Historic Preservation Commission

Wednesday, April 8, 2026

ZHPC-0126-000003 - 1076 Canton Street - Certificate of Appropriateness for a change to the proposed partial demolition plan

CITY OF ROSWELL, GA PLAN CONDITIONS REPORT (ZHPC-0126-000004)

DATE	1/14/26	DRAWN	DCP	CHECKED	JAS
SCALE	1" = 30'				
SHEET TITLE	DEMO PLAN

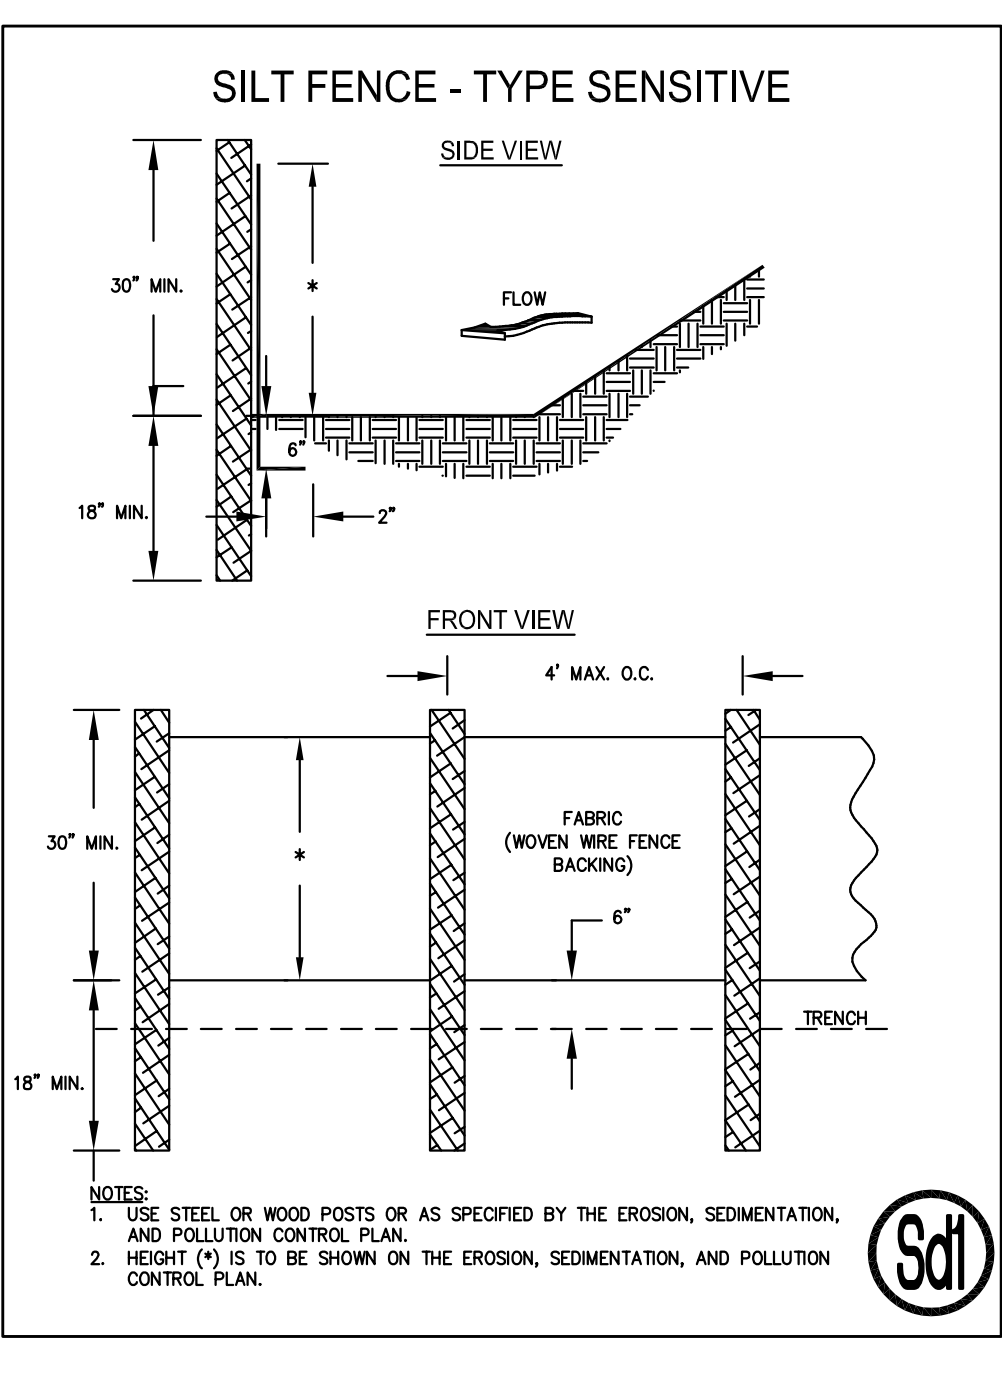
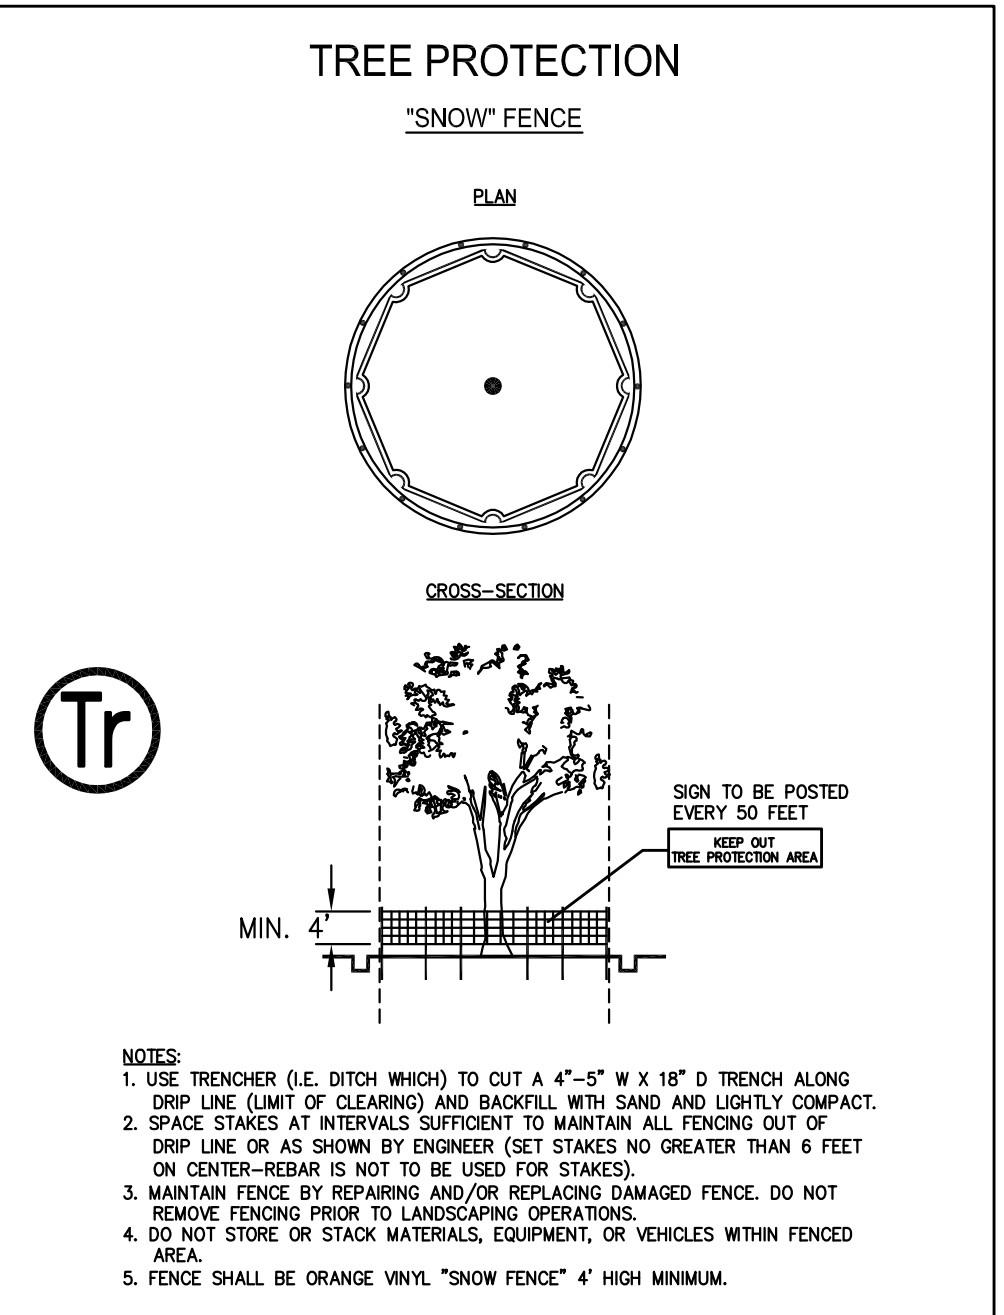
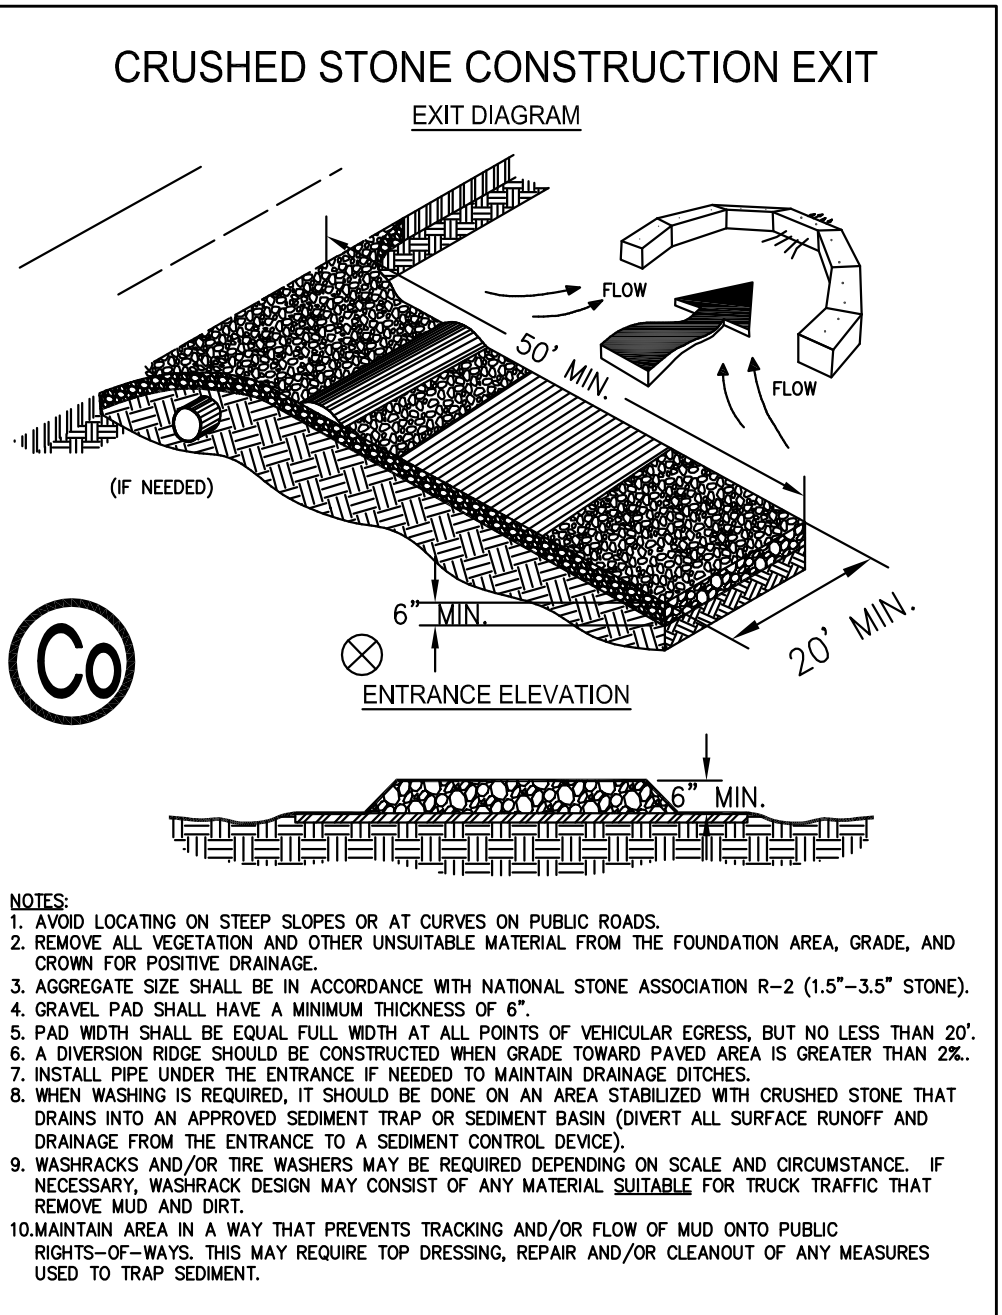
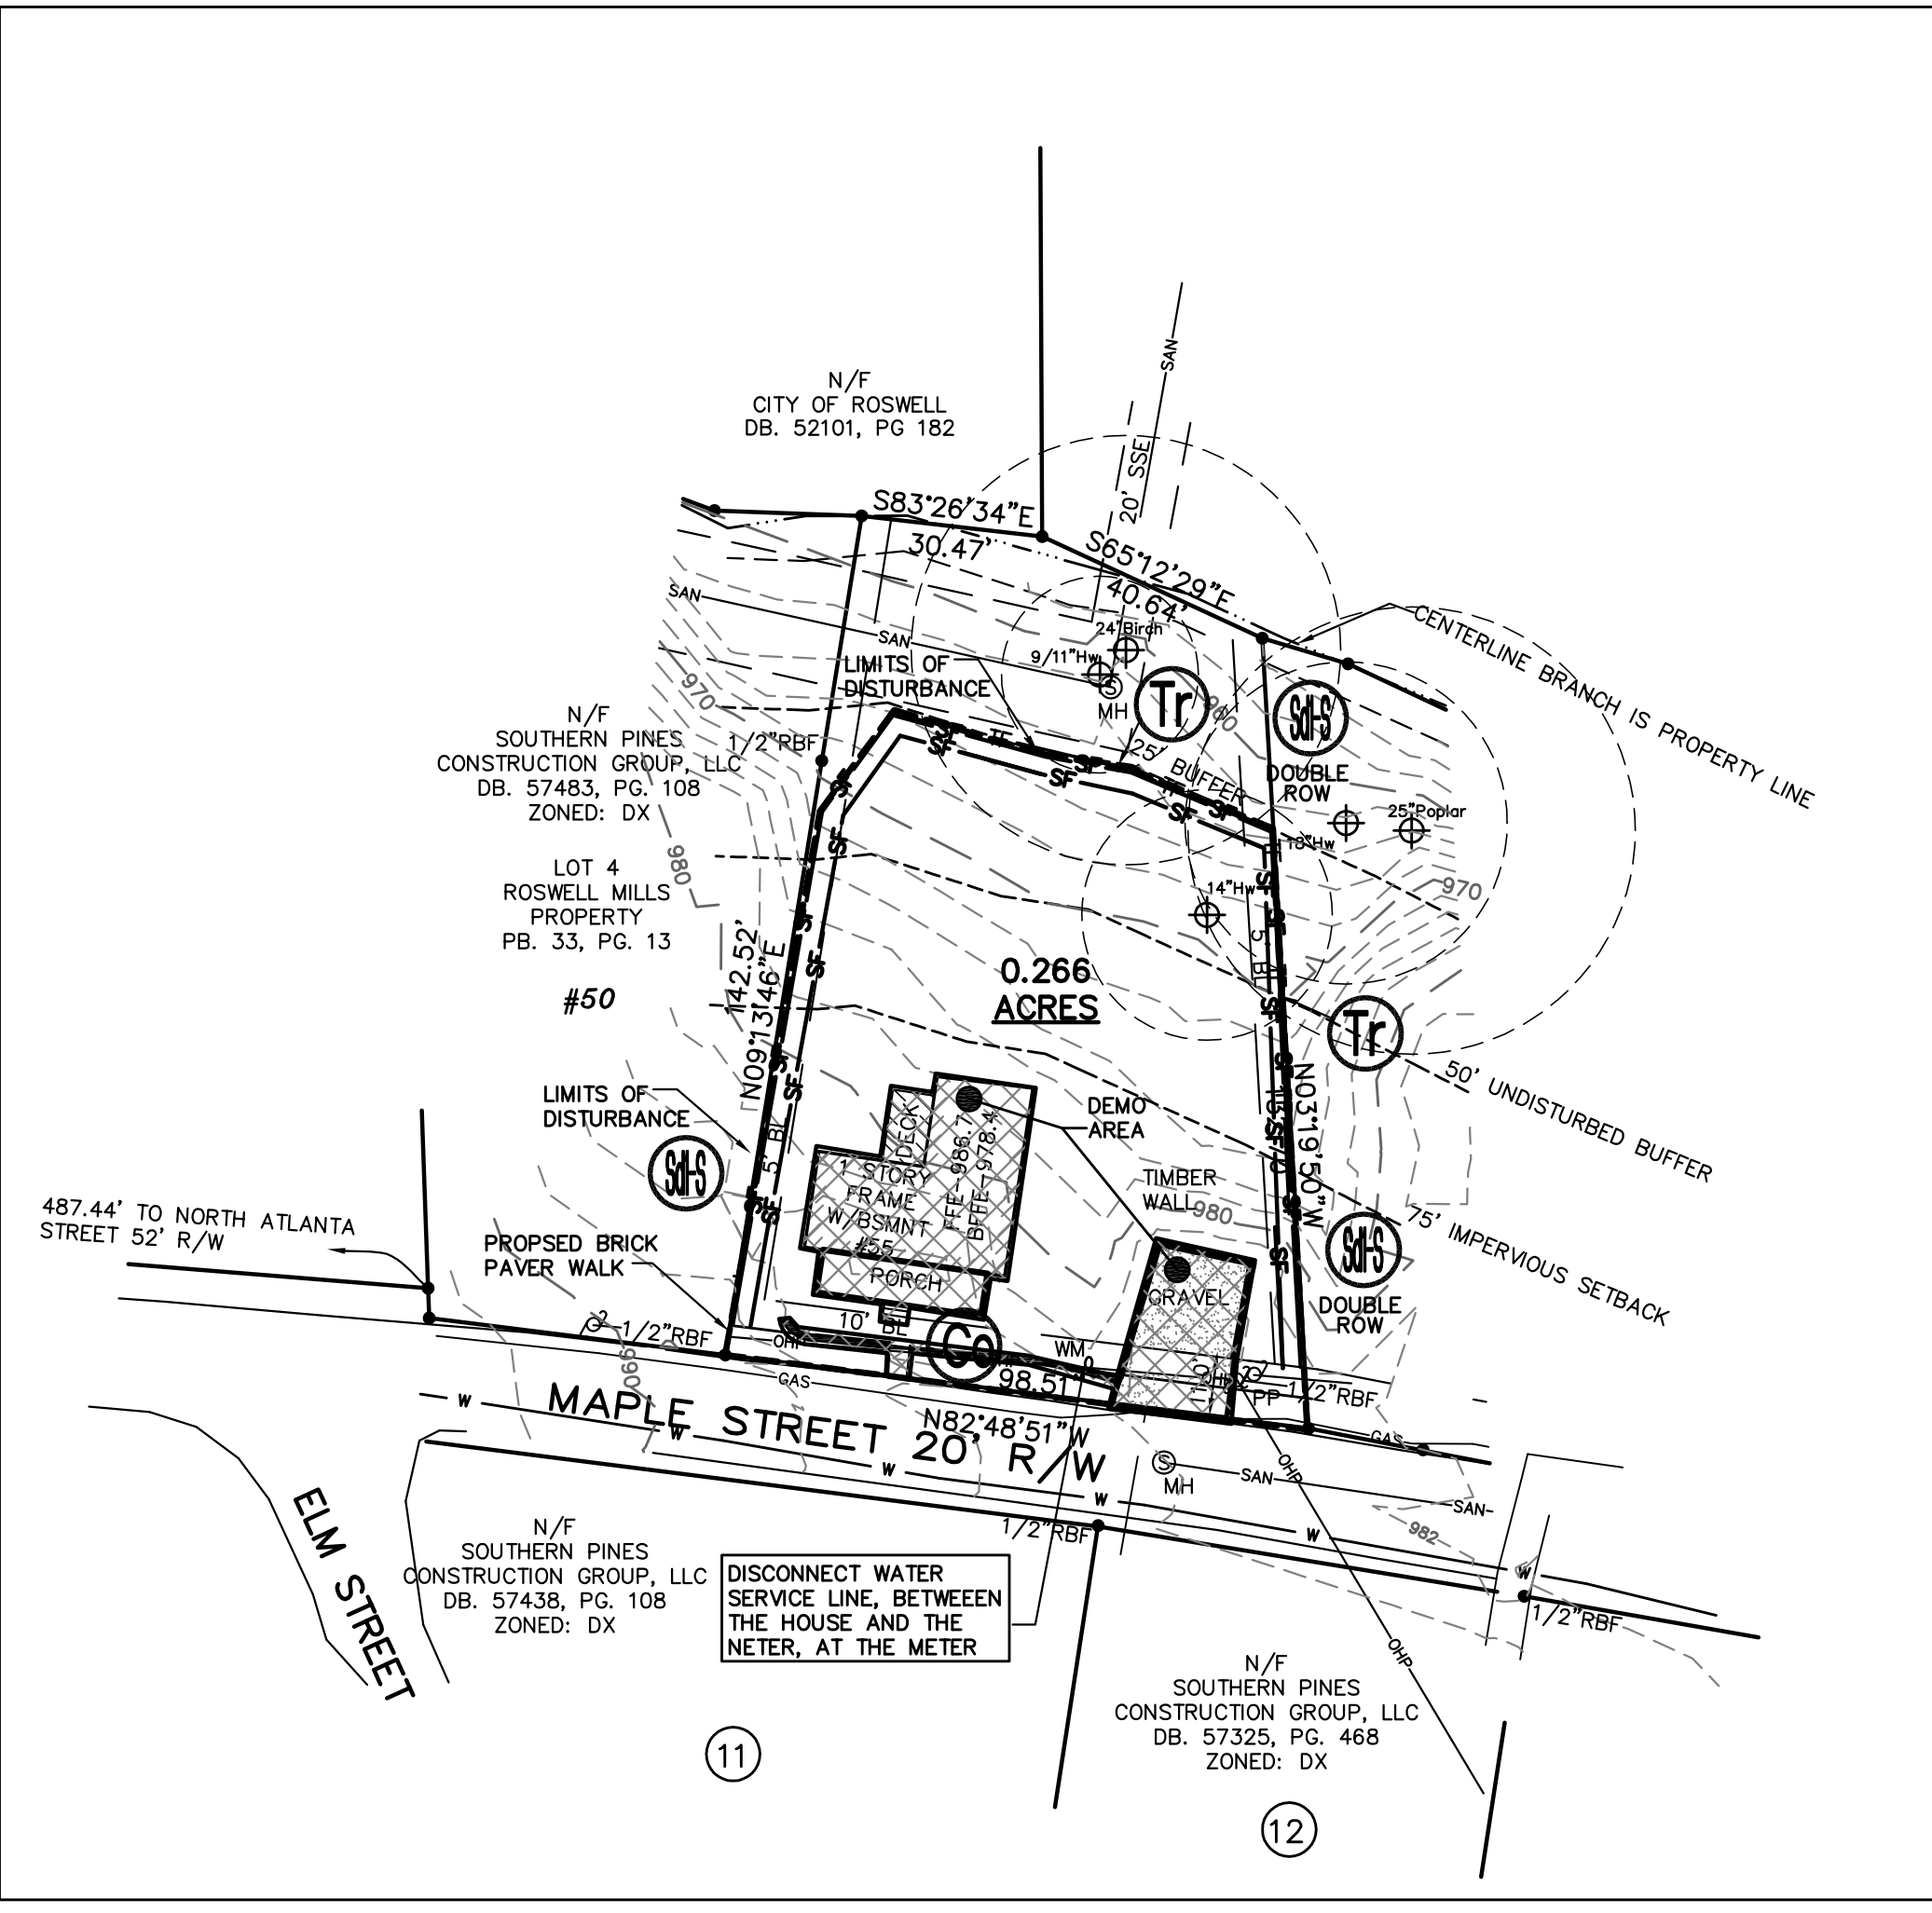
Comments: 1. Show and label tree protection fencing. There is a 'Tr' symbol but no linetype/linework labeled.

2. Trenching prohibited within root zone of preserved trees. "Keep Out - Tree Protection Area" signs to be posted every 50 feet along protection fence. Rev or provide alternate detail.

Comments: Need to show location of meter box and backflow prevention device on site plan sheet and Utility plan sheet.

Comments: Need to add note on plans, to disconnect the water service line, between the house and the meter, at the meter.

Need to add disconnect note - On Demo Plan Sheet D-1, need to correct the spelling on meter in the note to disconnect the meter between house and the meter. You spelled meter as "neter".

Comment: On Demo Plan Sheet D-1, need to correct the spelling on meter in the note to disconnect the meter between the house and the meter. You spelled meter as "neter".

Figure 6. Proposed site plan for 55 Maple Street (provided by applicant)

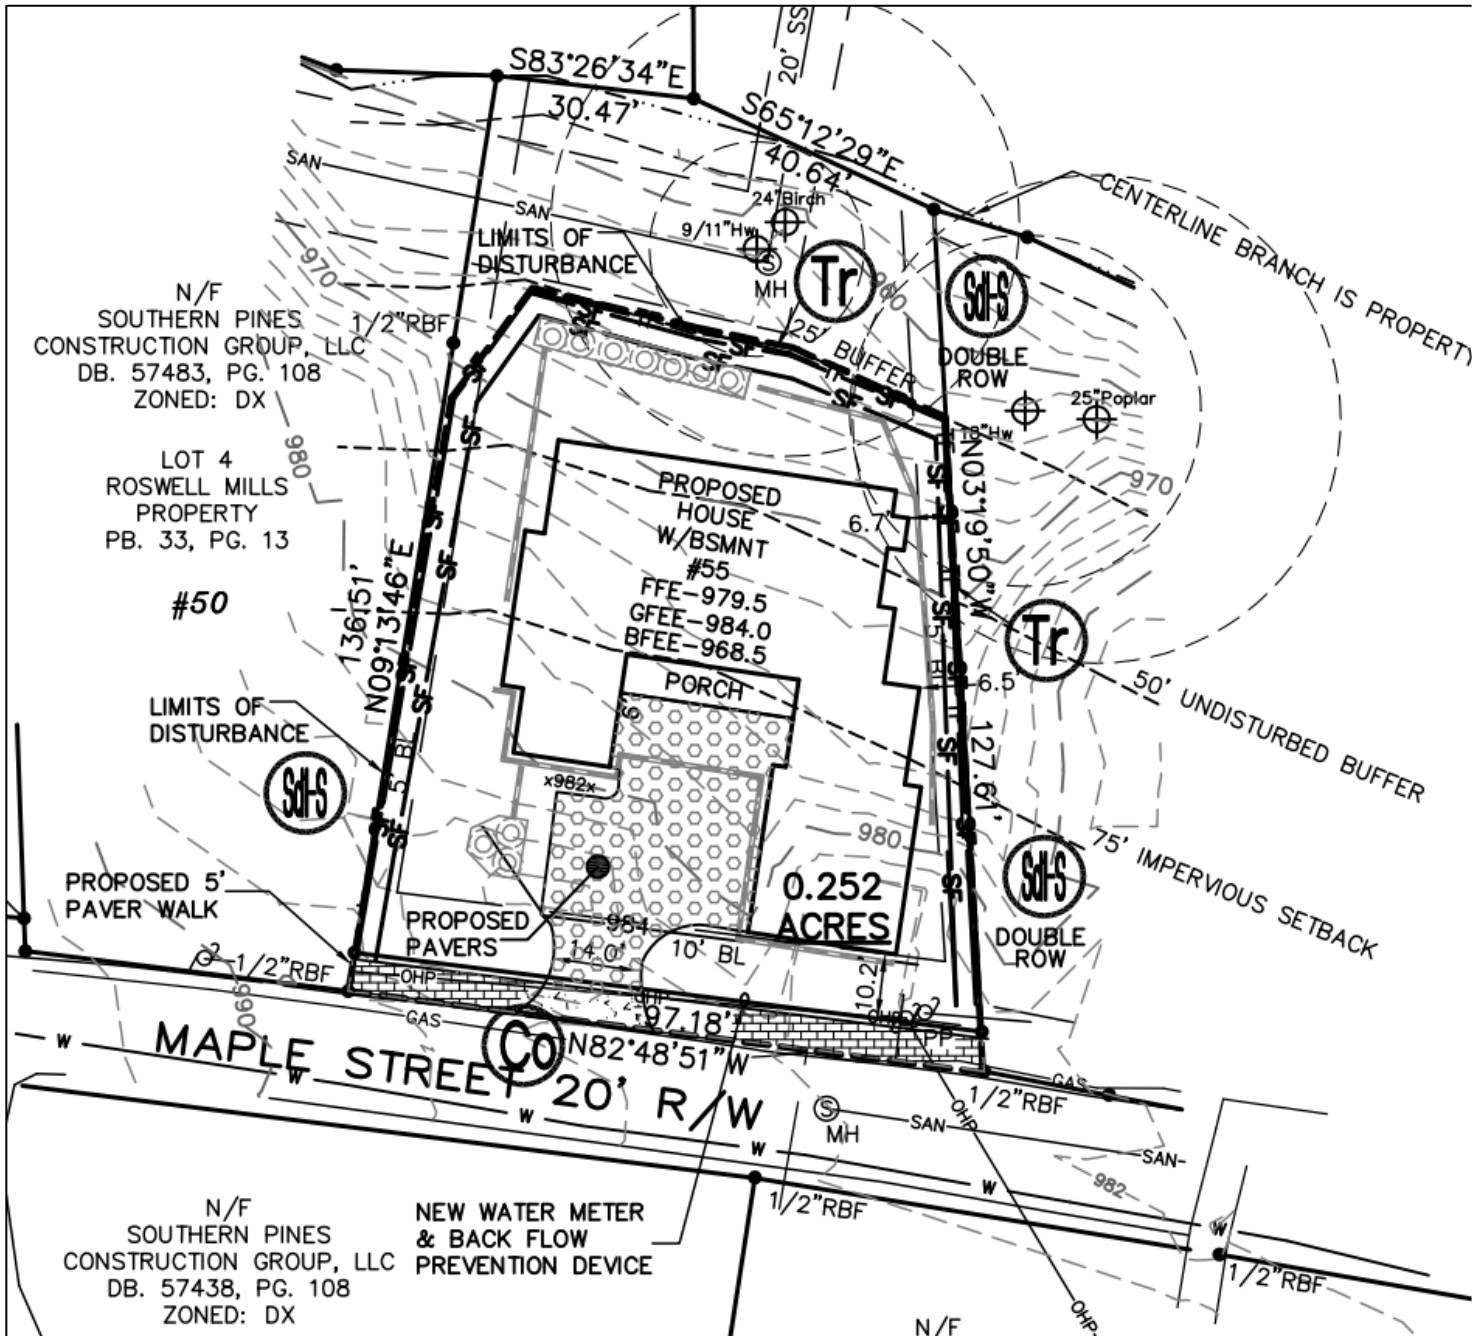
Section 4.25 – The visual impacts of residential garage doors on the streetscape should be limited. The garage is set up in a carriage court style, where the garage is entirely forward of the actual residence of the house, with doors that are perpendicular to the front plane of the house. This is not compatible with the historic context. The UDC Design Guidelines recommends against garage doors being flush with the front plane of the house, let alone being forward of the front plane. The design does not include any additional landscape or hardscape that would limit the primary garage's visibility. The garage doors will not only have a highly visible impact on the streetscape, but are arguably the most immediately visible façade elements on the currently proposed structure.

- A. Please submit an enlarged site plan, provided site plans are difficult to analyze for code compliance.
- B. Fireplace is shown on floor plan (as shown on sheet A01), but not on site plan. Cannot determine if this affects encroachment into the side setback.
- C. Front porch may not be narrower than 5' per UDC 2.2.18.B.1.
- D. Development is in protected stream buffer. Applicants are in process to receive stream buffer variance; however, this has so far been delayed from approval.
